## New drive pulleys with integrated rope tightening

The latest igus® drive unit is equipped with new pulleys (since July 2011). They enable the user to tighten the wires for the robolink arm easily.

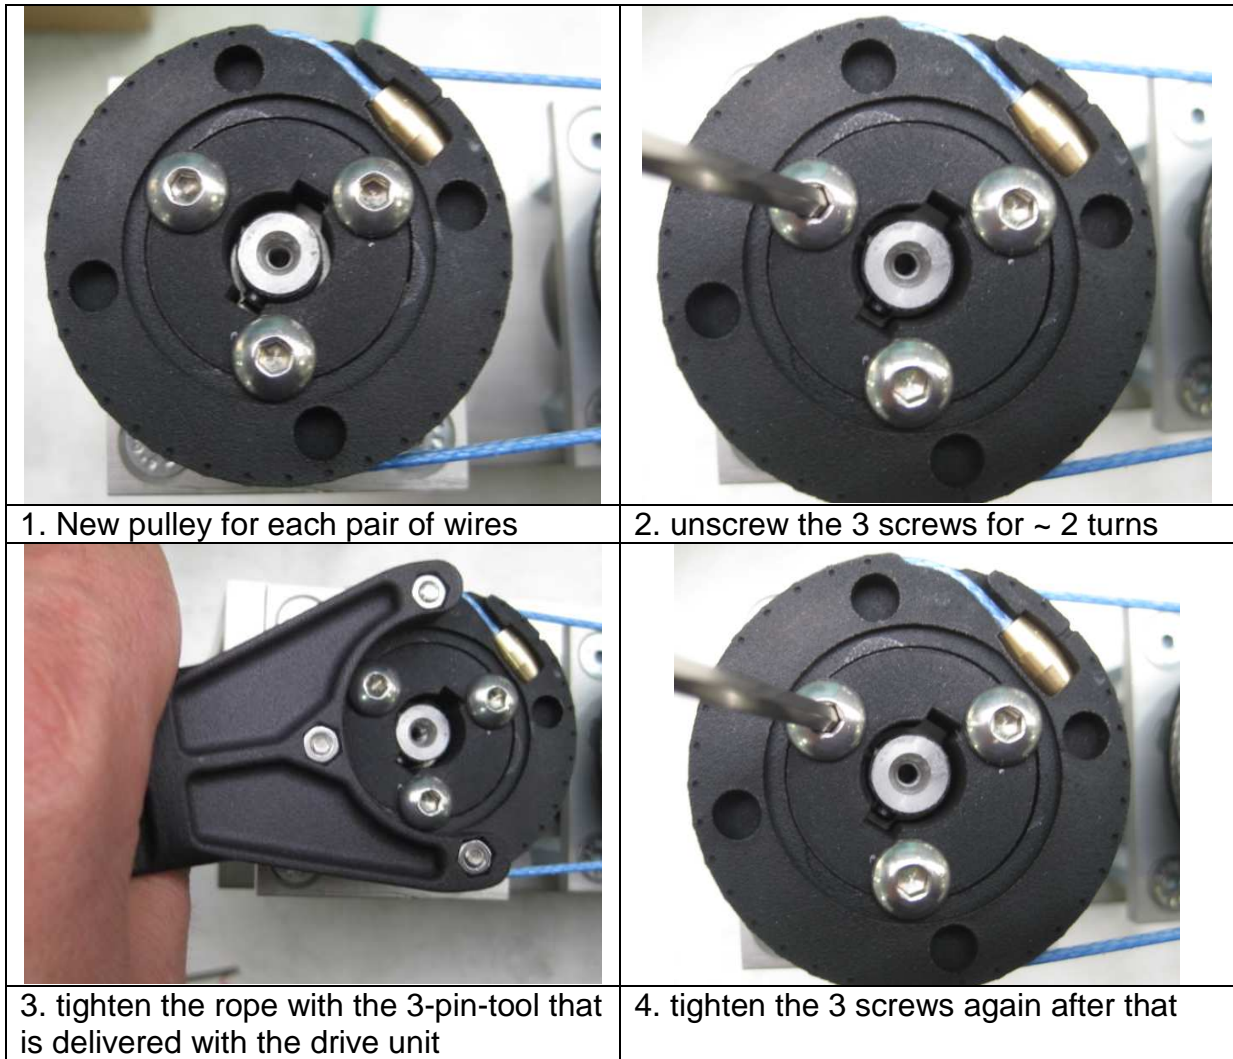
The tension of the wires can be adjusted individually:

- ⇒ If the tension is too low: the joint will have play (will bounce).
- ⇒ If the tension is too high: friction in the system will rise, all components will be wearing faster
